DART AEROSPACE LTD	Work Order:	159204
Description: Crosstube Assembly, Mid Fwd	Part Number:	D206-667-147
Inspection Dwg: D206-667-147 Rev: A		Page 1 of 2

DART AEROSPACE LTD HAWKESBURY, ONTARIO, CANADA	
DRAWING NO. D206-667-147	REV. A SHEET 1 OF 4
TITLE CROSSTUBE ASSY (206L MID FWD)	SCALE NTS

DRAWING NO. D206-667-147	TITLE CROSSTUBE ASS'Y (206L MID FWD)	REV. A	DART AEROSPACE LTD ENGINEERING ORDER		D.E.O. NO. D206-667-147-A-1	SHEET NO. SHEET 1 OF 1	SCALE NTS
DRAWN <i>q</i>	CHECKED <i>ASS</i>	MFG. APPR. <i>AS</i>	APPROVED <i>MD</i>		DE APPR. <i>MD</i>		
DATE 11.07.15	DATE 11.07.20	DATE 11.07.21	DATE 11/07/21		DATE 11.07.21

DRAWING NO. D206-667-147	TITLE CROSSTUBE ASS'Y (206L MID FWD)	REV. A	DART AEROSPACE LTD ENGINEERING ORDER	D.E.O. NO. D206-667-147-A-2	SHEET NO. SHEET 1 OF 1	SCALE NTS
DRAWN AJS	CHECKED	MFG. APPR. <i>E</i>	APPROVED <i>AD</i>	DE APPR. <i>AD</i>		
DATE 12.08.02	DATE 12.08.02	DATE 12.08.02	DATE 12.08.02	DATE 12.08.02	DATE 12.08.02

DETAIL P
BONDING STRAP INSTALLATION 2 PL

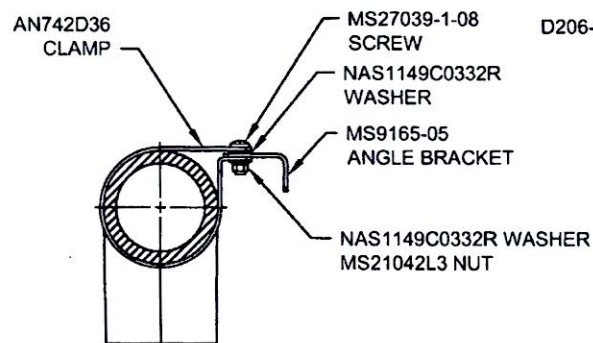
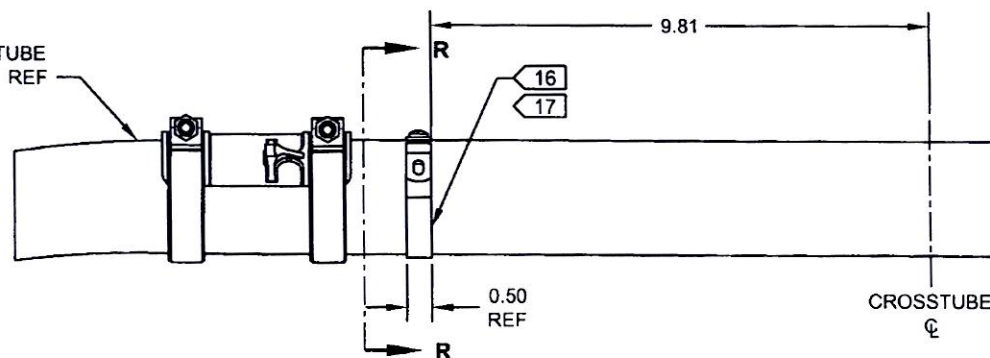
ADD ELECTRICAL GROUNDING STRAP

ITEM	QTY -147	PART NUMBER	DESCRIPTION
1	X	D206-667-147	CROSSTUBE ASSEMBLY (206L MID FWD)
10	2	AN742D36	CLAMP
11	2	MS9165-05	ANGLE BRACKET
12	2	MS21042L3	NUT (OR MS21042-3)
13	2	MS27039-1-08	SCREW
14	4	NAS1149C0332R	WASHER (OR AN960C10L)

- 16) MASK AREA UNDER CLAMP PRIOR TO PAINTING
- 17) SEAL EDGES WHERE AN742D36 CLAMP MEETS WITH THE CROSSTUBE USING SIKAFLEX-241/-291 OR MIL-S-8802 CLASS B2 OR PROSEAL 890 SEALANT
- 18) PERFORM RESISTANCE CHECK TO ENSURE MAX RESISTANCE IS 10 MILLIOHMS
